ADA Curb Ramp New Construction Inspection Form (Combination)

NW 307th

23885.56

NW Pacific

COMBINATION RAMP (C)

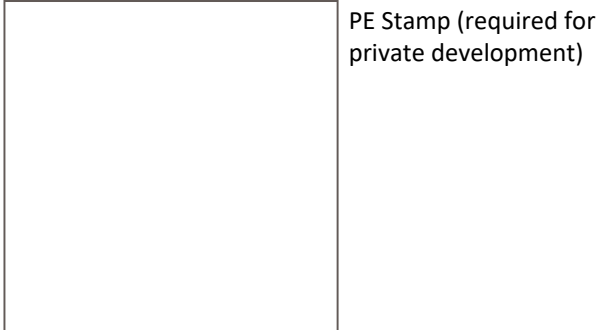
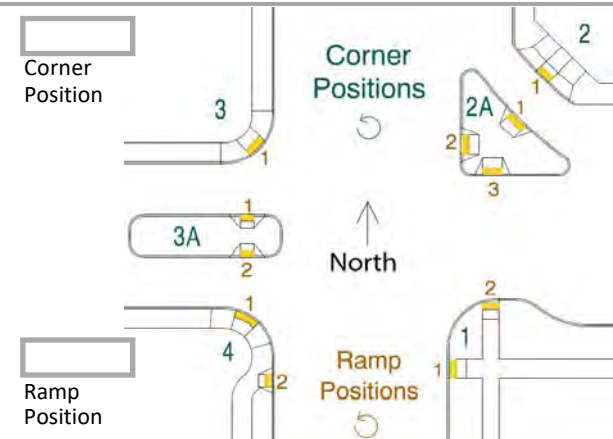
RR2/RR3 clear width 74', IITD
